# CONVENT ROAD ACTIVE TRAVEL SCHEME

## QUALITY AUDIT

*03 December 2025*

Wicklow County Council

### 4.2 Priority Control at Roundabout

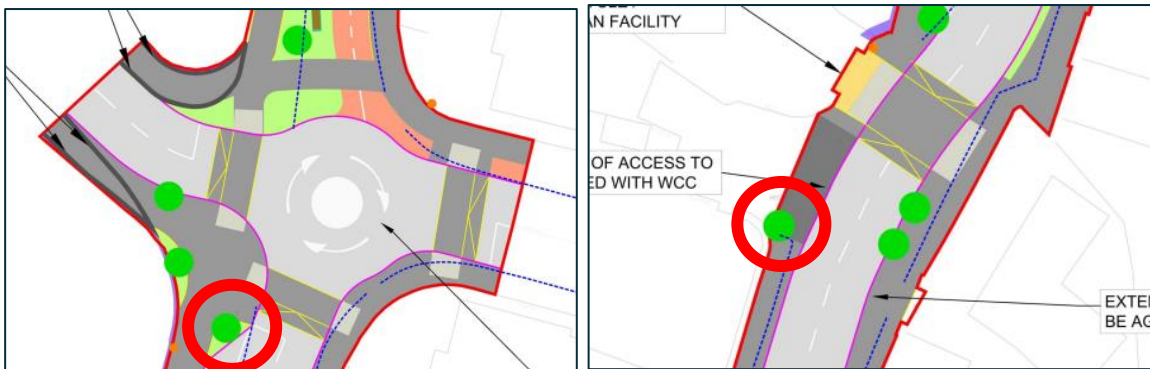
There are currently no priority control markings for cyclists at this roundabout, this could lead to cyclists failing to yield on their return to the carriageway and could result in collisions between vehicles and cyclists.

A safe transition to and from the two way cycle track for cyclists and clear priority control should be provided to all road user at this junction

### 4.3 Unregulated Parking

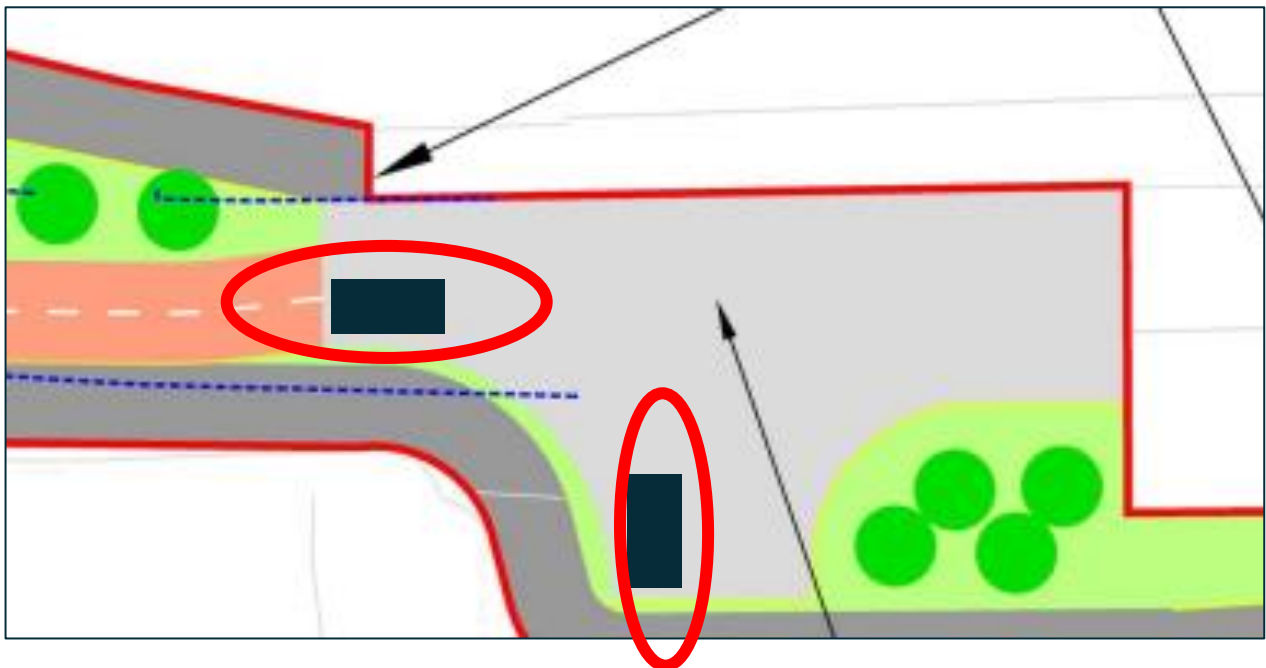
There is the possibility that vehicles may partially park on the footpath for a short period while visiting a shop or similar for example. This would most likely occur near dished accesses or at the junction heads. This unregulated parking would be unsafe for all road users especially pedestrians on the footpath or at the crossings.

The designer should incorporate measures into the scheme to prevent unsafe parking practices, particularly at critical areas of the scheme such as near accesses or at the raised tabletop junctions.

## 4.6 Reduced Sightlines at Convent Road and Church Road Junction

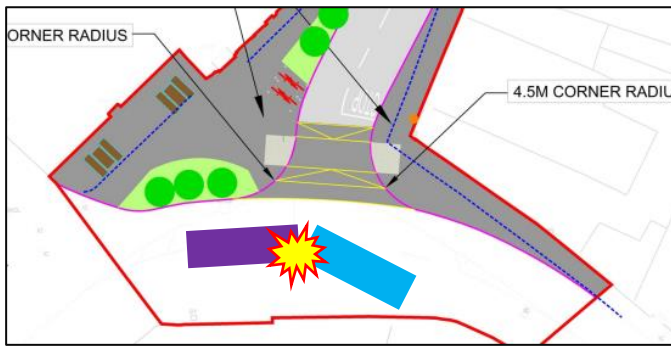
Trees are proposed to the west of the junction of Convent Road and Church Road. These trees could reduce the necessary sight distances at the junction and this could lead to side swipe or rear end shunt type collisions.

The designer should provide adequate visibility between vehicles at this junction.

### 4.8 Narrow Carriageway

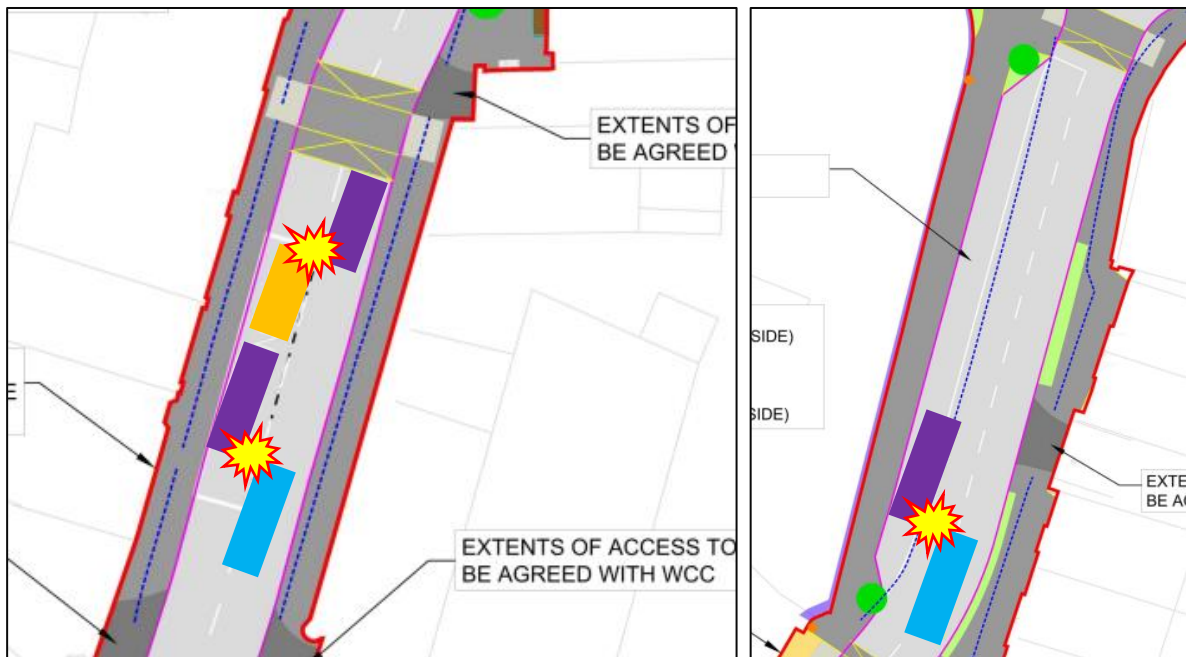
The carriageway appears to be narrow between the loading bay and the parking bays towards the north of the scheme. This could lead to side swipe collisions between vehicles and poorly parked vehicles in the loading and parking bays. This issue could be particularly problematic for emergency vehicles and refuse trucks.

The designer should confirm that all necessary manoeuvres by all vehicles can be accommodated and provide additional space where required. Ensure that the minimum carriageway width for fire tender access is provided.
